Town of Franklin

Planning Board

June 8, 2020

- 7:00 PM Commencement/General Business
- 7:05 PM <u>PUBLIC HEARING</u> Continued 176-210 Grove Street Site Plan

PROJECT: PARKING EXPANSION 12 FORGE PARKWAY FRANKLIN, MA

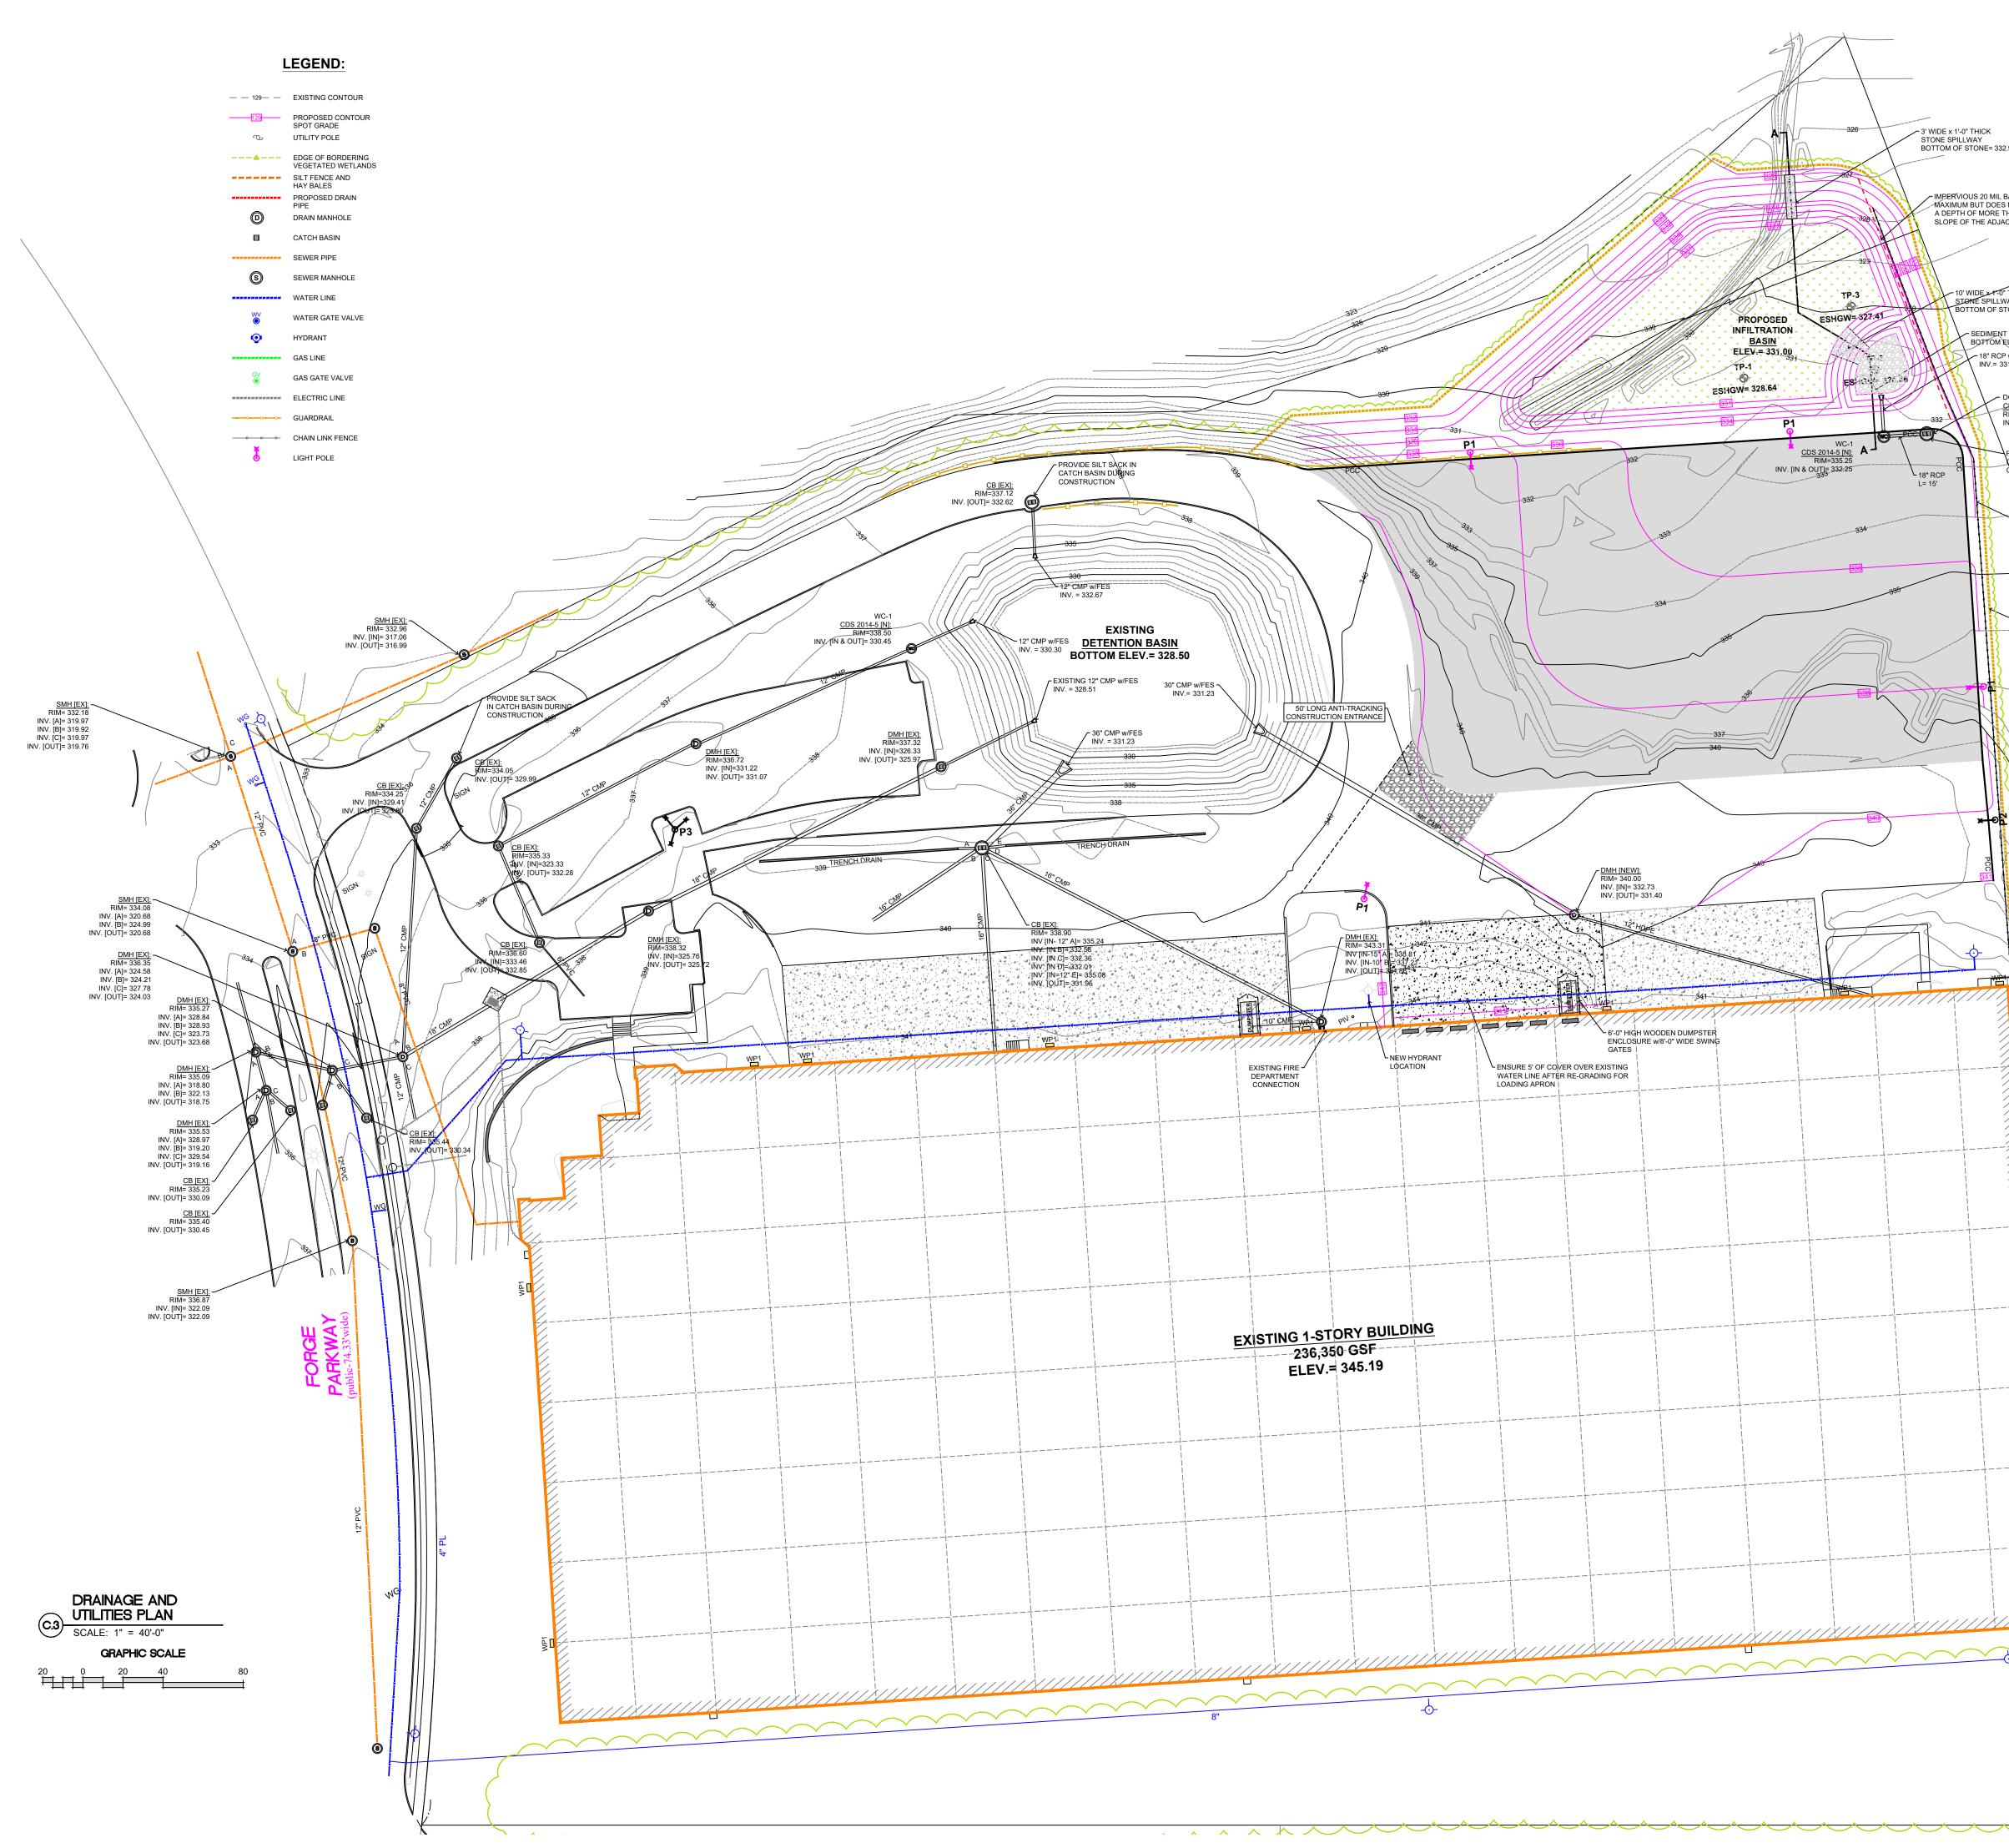
show parking availabilit 12. Prior to Endorsement, the following changes are to be made to the plans

. Signage should be added to the plans to show "No idling:" where the truck parking is located

The curbing shall be reinforced concrete and should be on the plans and in the details
 A natural color fence shall be installed along the property, as shown on the plans The dumpster shall be on a concrete pad with a fence e

DATE
T T NITED	MAR. 4, 202
UMONSULTANTS	scale $1^{"} = 20^{'}$
INC	PROJECT
850 FRANKLIN STREET SUITE 11D	UC1334
WRENTHAM, MASSACHUSETTS 02093	SHEET
508-384-6560 FAX 508-384-6566	4 of 9

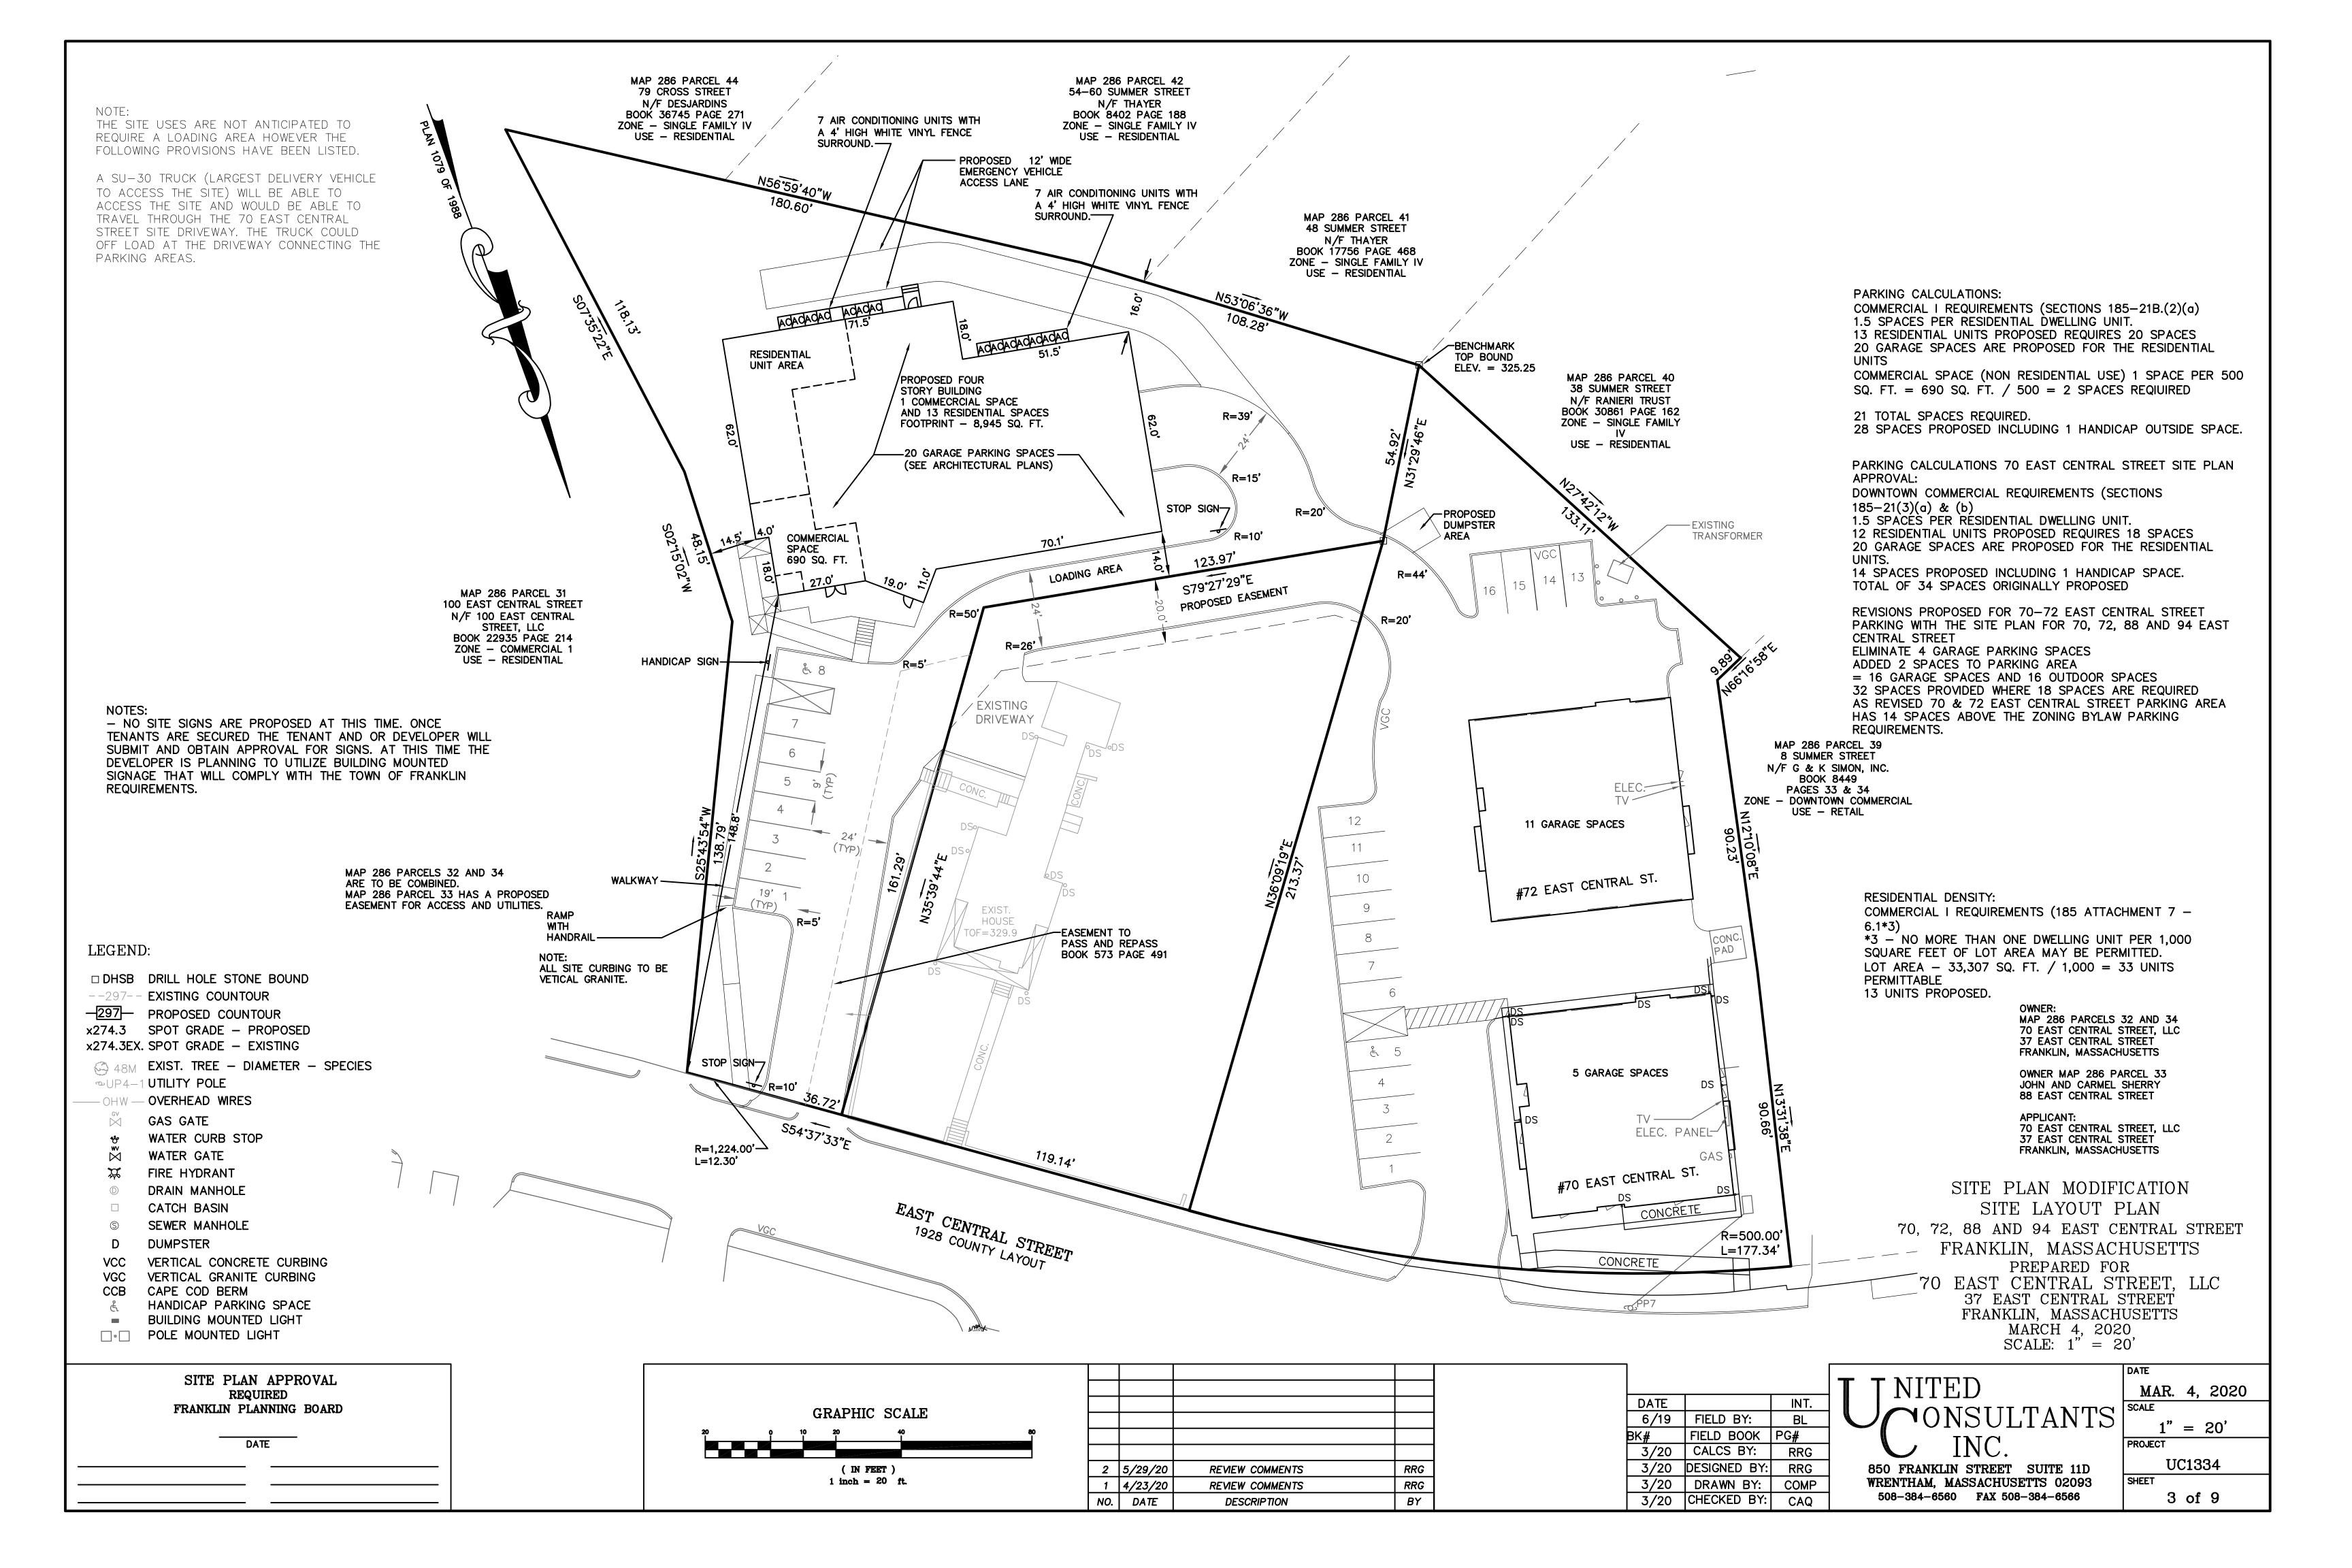
- S1. Provide general sound information for proposed HVAC equipment (§185-31.C.(3)(r)). UCI: The applicant is proposing to utilize residential type HVAC equipment that is similar to the 70 and 72 East Central Street buildings. **BETA2: Information provided. BETA does not anticipate adverse sound impacts to abutters issue dismissed.**
- S2. Provide sight line information at the proposed driveway (§185-31.C.(3)(t)). UCI: Sight distances have been added to sheet 4. BETA2: Information provided issue resolved.

- U2. Revise Utility Note 1 to be consistent with Existing Utility Note 1, as necessary. Recommend having a single compilation of utility notes. *UCI: Note has been revised. Existing utility notes were added to utility note section.* BETA2: Revise Note 7 to indicate the existing water service will be cut and capped at the main per DPW requirements. *UCI2: Note 7 has been revised on Sheet 4 of 9.* BETA3: Note revised issue resolved.
